Rezoning Transportation Analysis
Petition Number: Insert Zoning Petition #2021-018
General Location Identifier: Tax ID 07908301

Revision Log:	Date	Description
	02-25-21	First Review (EL)

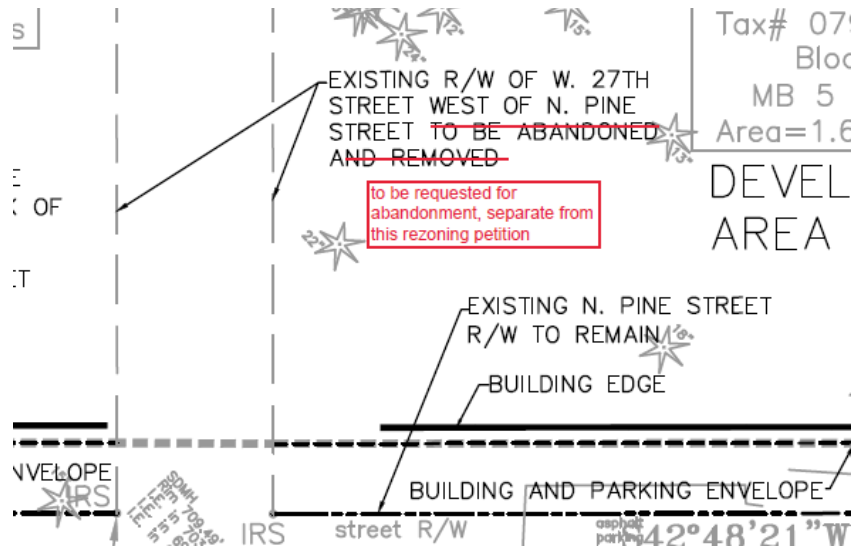
5. A site plan notespecifying dedication and fee simple conveyance of all rights-of-way to the City before the site's first building certificate of occupancy is issued is needed. CDOT requests rights-of-way set at 2' behind back of sidewalk where feasible.
6. A site plan note specifying that all transportation improvements will be approved and constructed before the site's first building certificate of occupancy is issued is needed. The petitioner may phase transportation improvements if said improvements and phasing are explicitly described in site plan notes.
7. On sheets RZ-1 and RZ-2, remove call-out to abandon and remove W. 27th Street. Also, remove the site conditional note 3. Access, Buffers, Screening, Open Space and Pedestrian Circulation, Note I. The abandonment of W. 27th Street is not consistent with the USDG Standards (see image below).
